Summary of Proposed Amendments to the Trent Source Protection Plan and Assessment Report – Grafton Drinking Water System

Pursuant to Section 34 of Ontario Regulation 287/07 of the Clean Water Act

December 15, 2025

The Township of Alnwick/Haldimand is revising the Wellhead Protection Area (WHPA) for the Grafton Drinking Water System (DWS) due to the installation of one new municipal well. These upgrades have resulted in the Proposed Amendments to the Trent Source Protection Plan (SPP) and Assessment Report (AR) (last updated and approved June 13, 2025) listed below and summarized and highlighted in yellow on the following pages. A strike-through indicates that text is to be removed.

Trent Assessment Report Map 5-31a

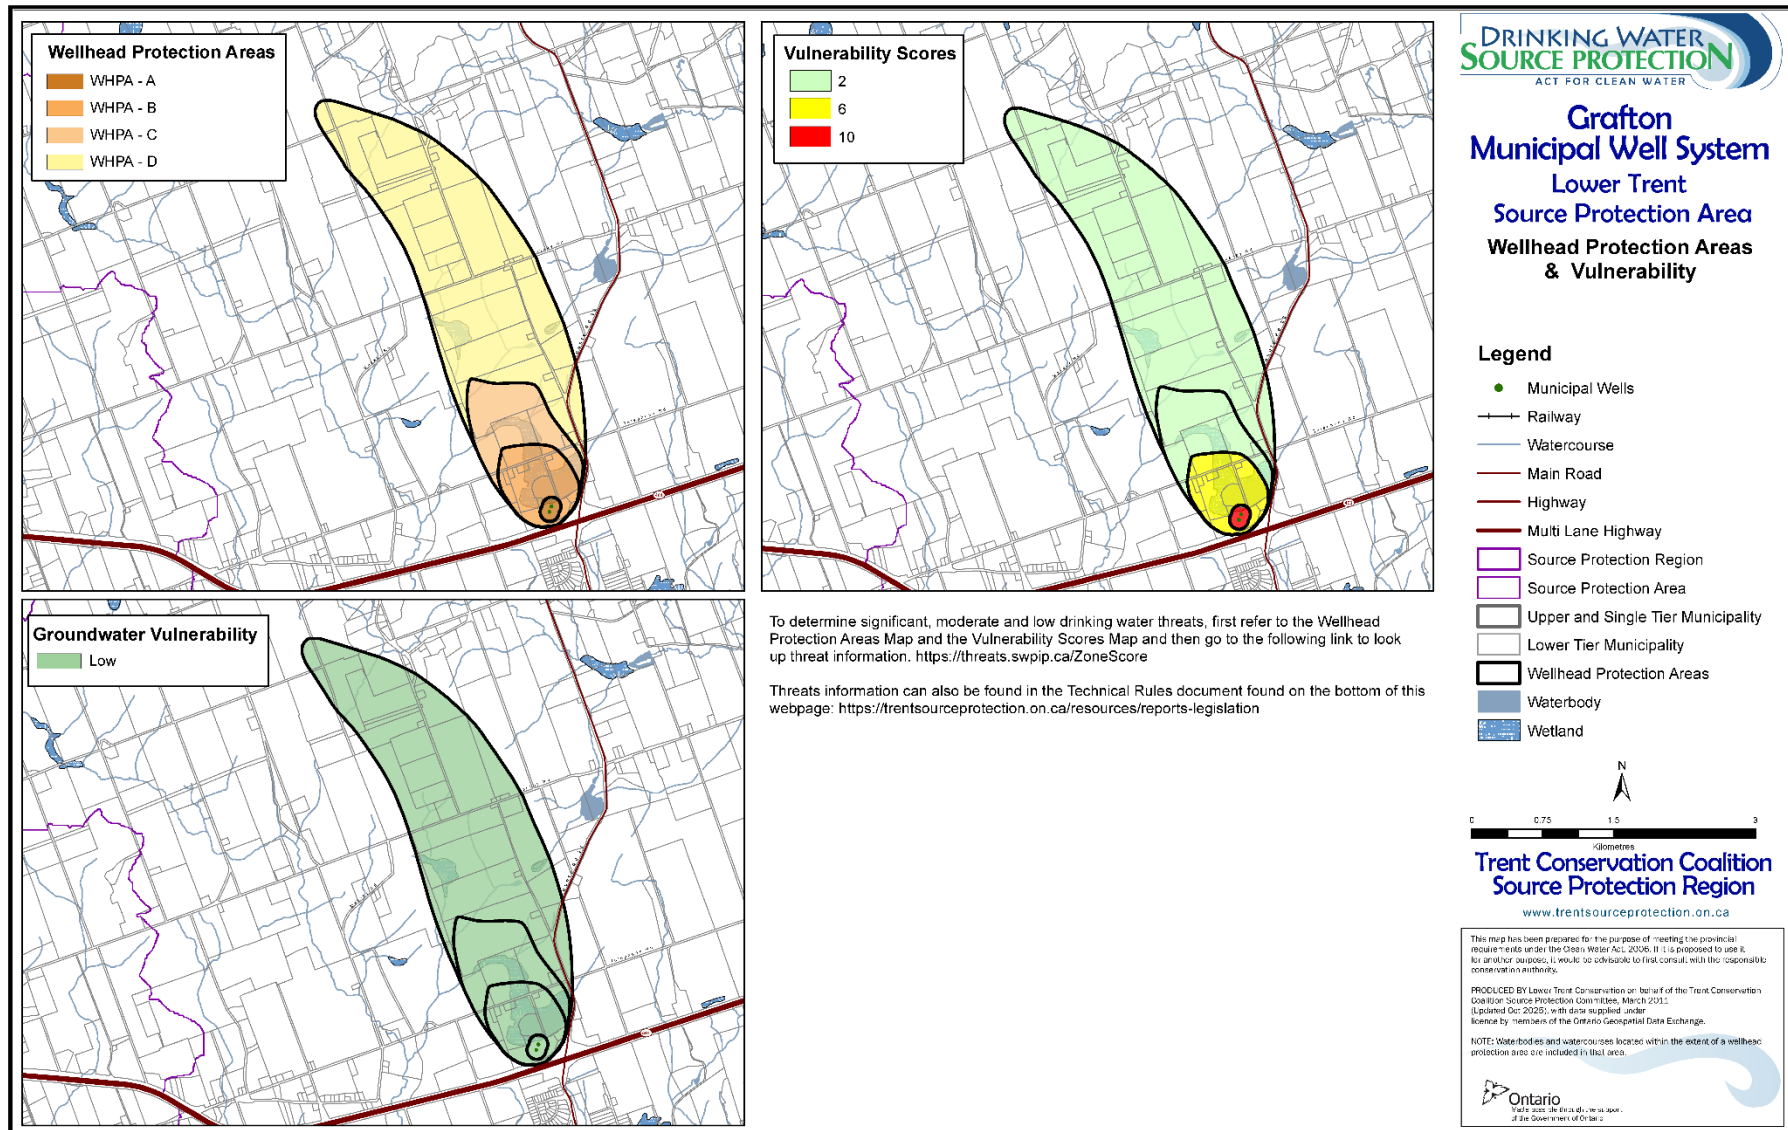
Amendment 11: Map 5-31a, Map 5-31b – Updated to reflect new WHPA
